Department of Environmental Quality

December 1, 2014

Submitted electronically via www.regulations.gov
Attn: **Docket No. EPA-HQ-OAR-2013-0602**

Re: Carbon Pollution Emission Guidelines for Existing Stationary Sources: Electric Utility Generating Units

Figure 1: Wind Potential Class 4 and Higher in Wyoming

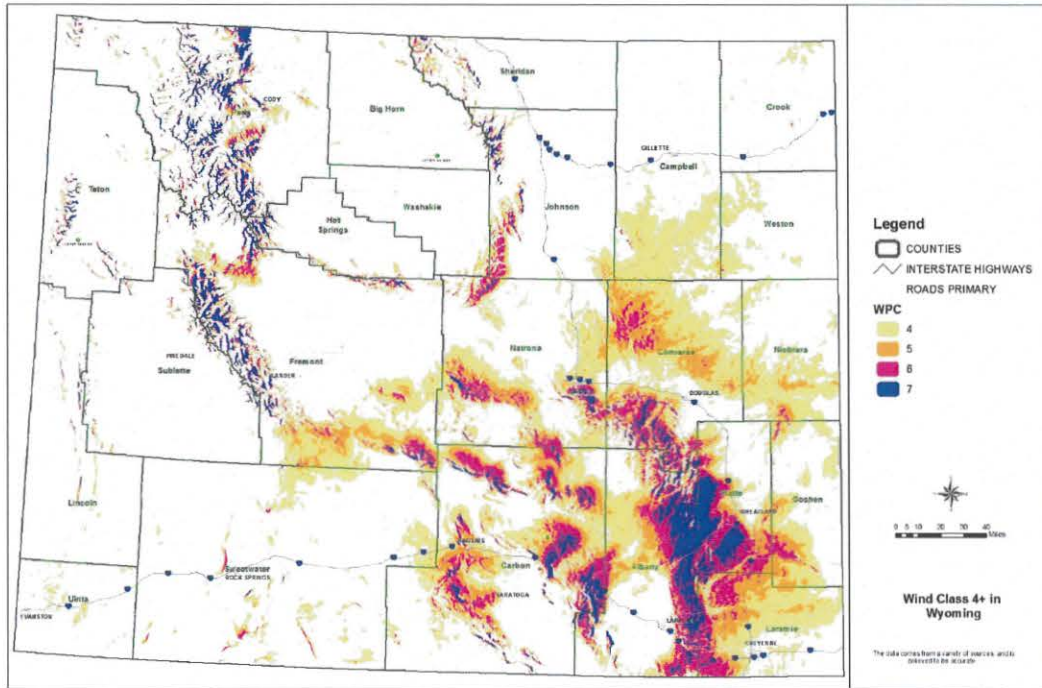
When the areas of land restricted from development for designated core habitat areas and other protected areas are compared to the land identified for wind development, as illustrated in Figures 1 and 2, the conflict is evident. Specifically, 3,563,040 acres (14,419 km²) of Wyoming land classified as Wind Potential Class (WPC) 4 or higher cannot be developed for environmental reasons.

Figure 1, as represented below, identifies the land with WPC 4 and higher and considered commercially viable for energy generation. The map has no exclusions for protected lands. The map in Figure 2 illustrates the reduction in land available for development. The Greater Sage-Grouse core area, as well as cultural and historical lands that are protected and unavailable for development, have been removed.
